**ADDENDUM
NO. 06**

**Richland-Bean Blossom CSC
Additions and Renovations**

CONTROLS CHANGES TO THE PREVIOUS ADDENDUM:

REPLACE THE FOLLOWING SHEETS IN ADDENDUM 4 WITH THE FOLLOWING

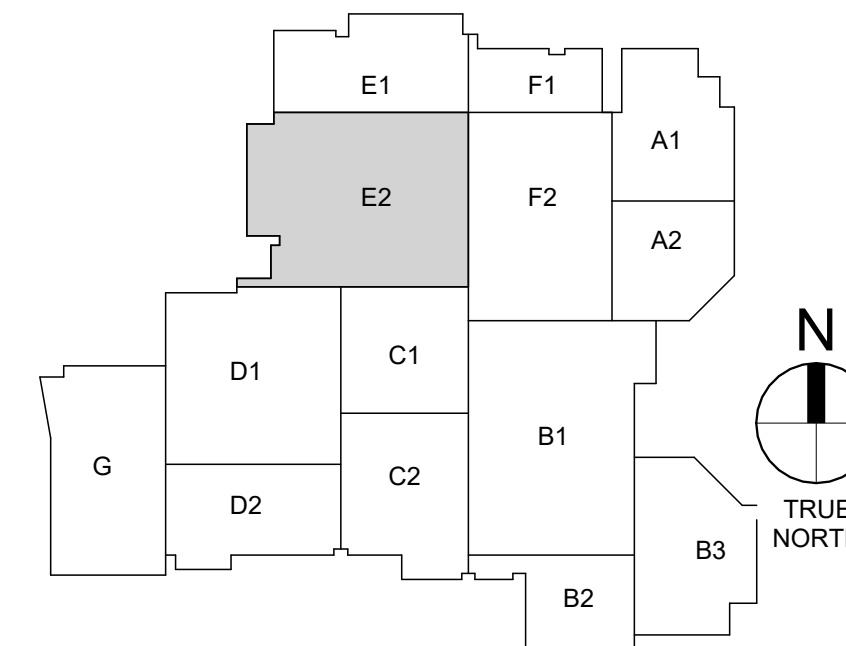
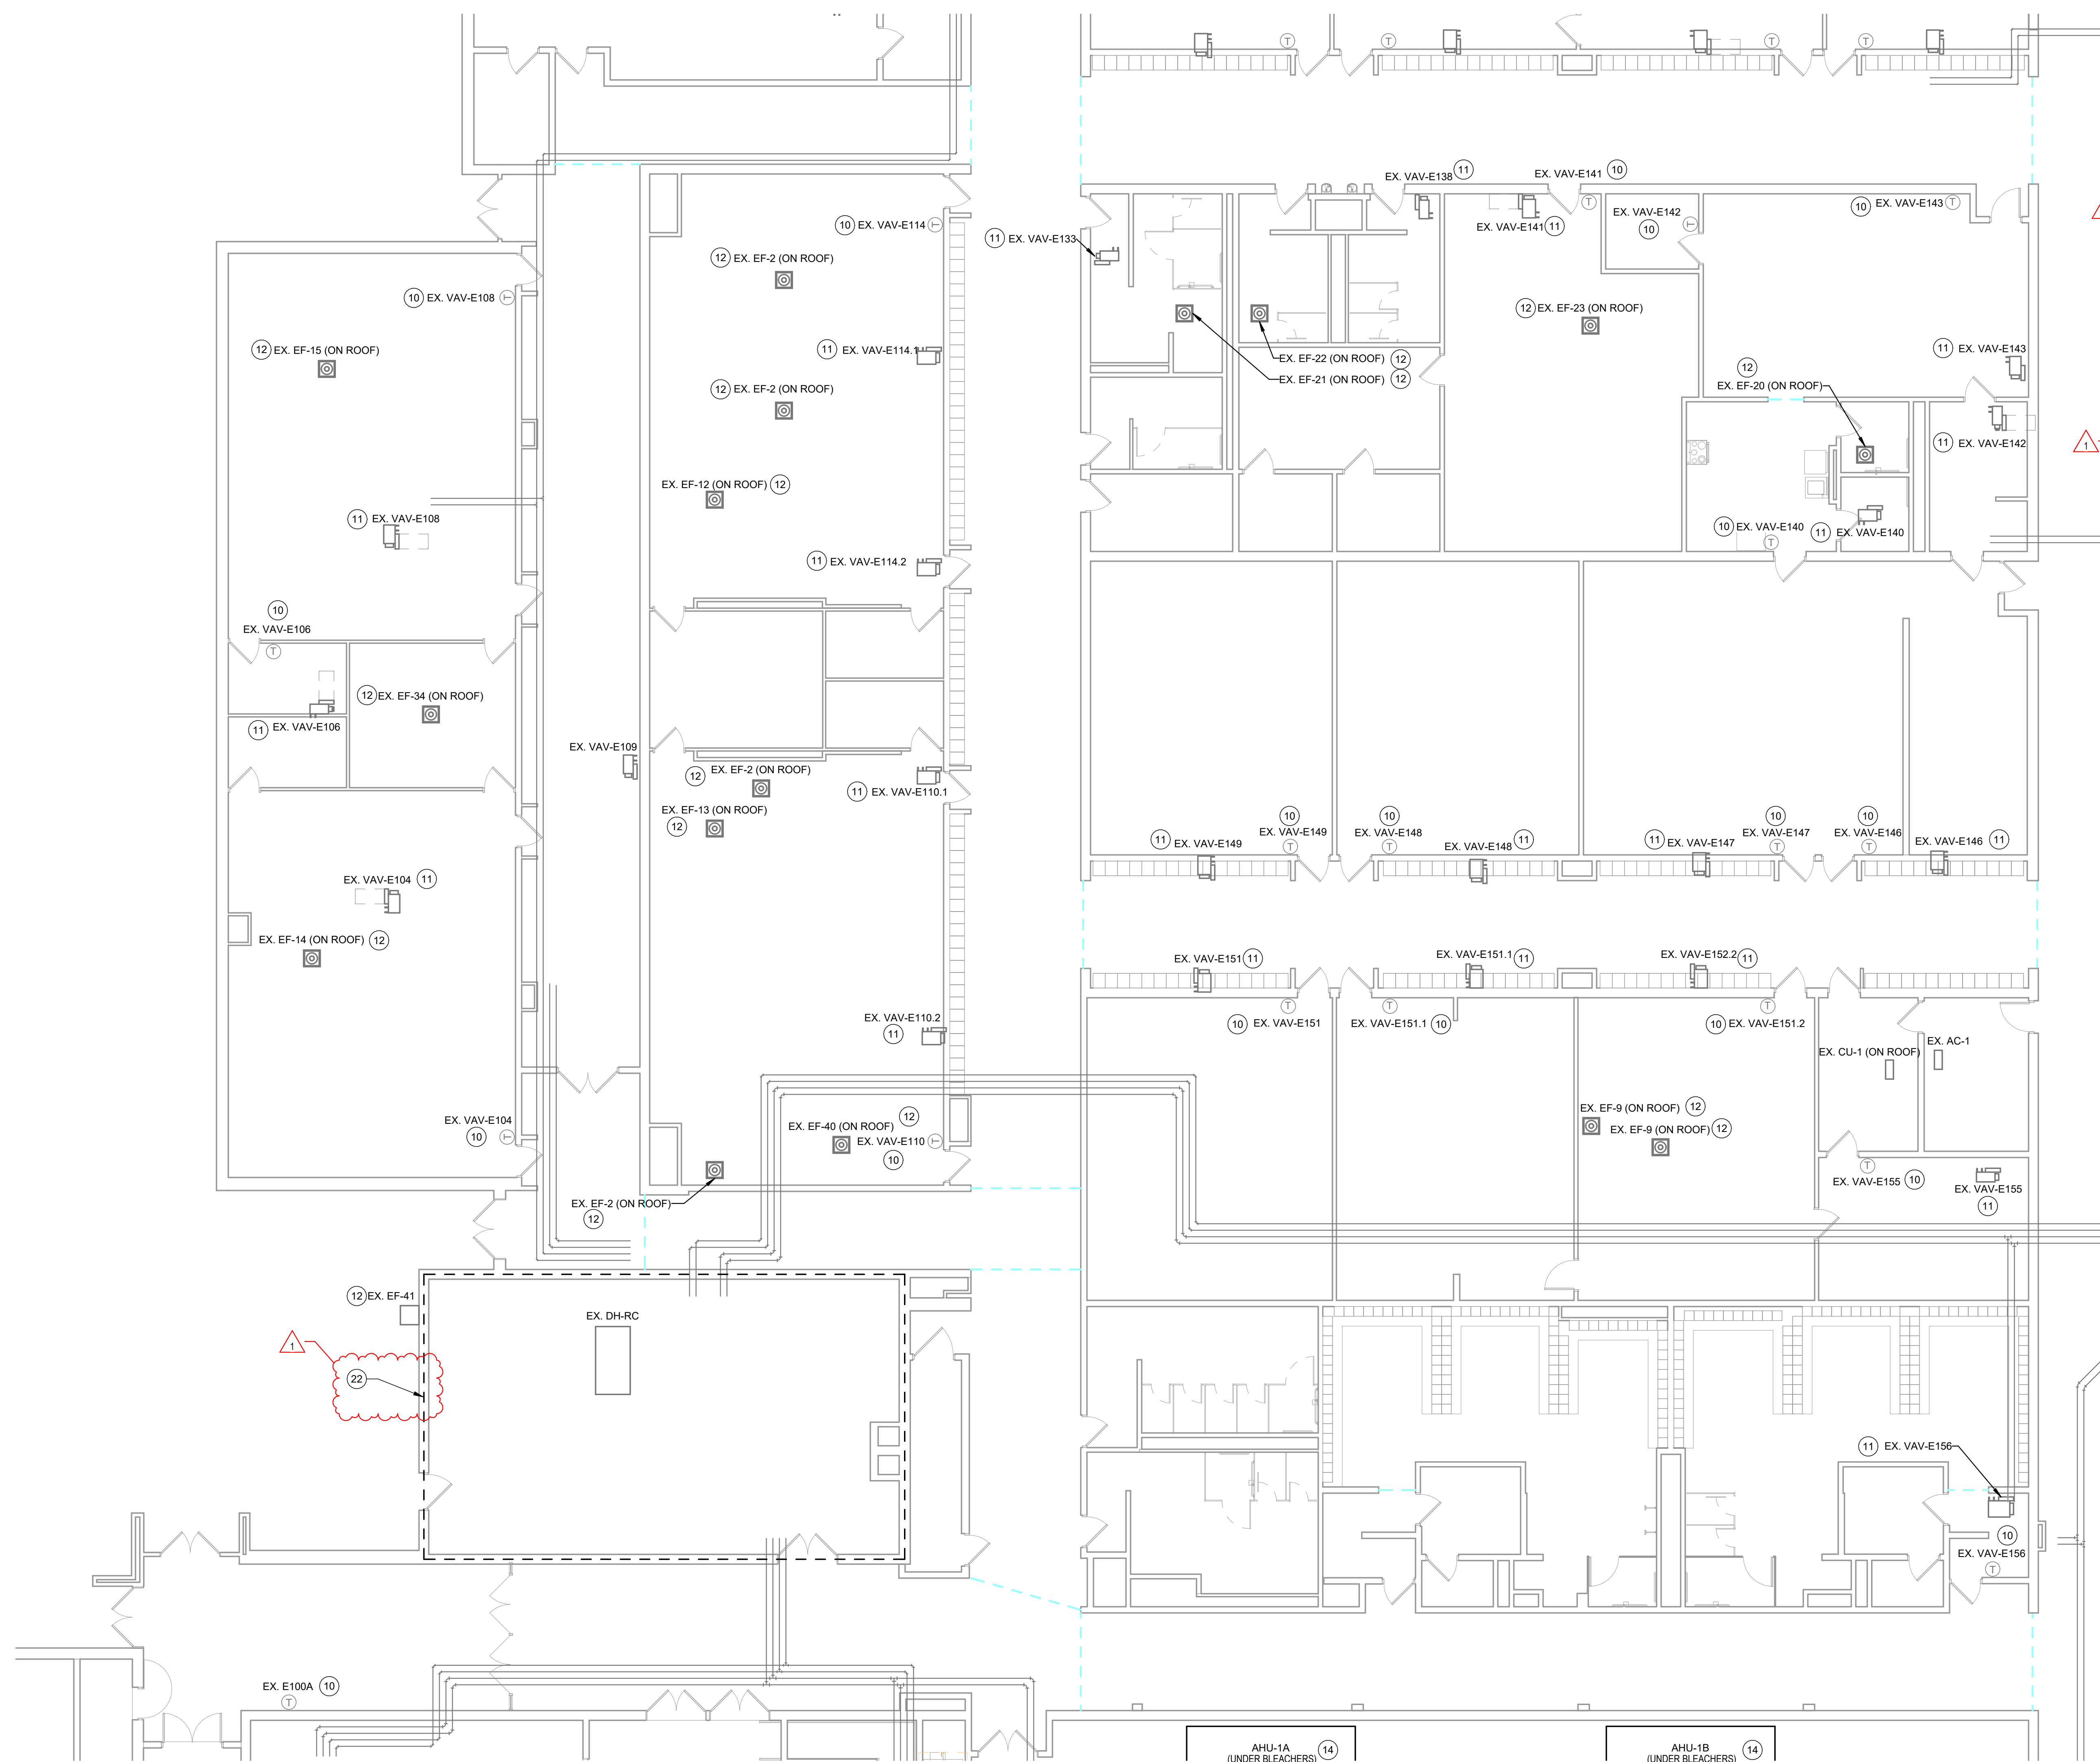
1. Drawing MP101B
 - a. REVISED NOTE 12

11. INTEGRATE NEW CONTROLS FOR EXISTING LIGHTING CONTROLS. SEE PHOTO THIS SHEET FOR EXISTING LIGHTING PLAN.
12. PROVIDE NEW CONTROL COMMUNICATIONS WIRING, DDC CONTROLLERS, AND SOFTWARE PROGRAMS FOR CENTRAL HEATING HOT WATER AND CENTRAL CHILLED WATER SYSTEMS. EXISTING CONTROLS DEVICES REMAIN, INCLUDING, BUT NOT LIMITED TO, VFDs AND TEMPERATURE CONTROL VALVES AND SENSORS. DOCUMENT EXISTING SEQUENCES OF OPERATION PRIOR TO DEMOLITION. MAINTAIN EXISTING SEQUENCES OF OPERATION FOR CHILLED WATER AND HEATING WATER SYSTEMS.
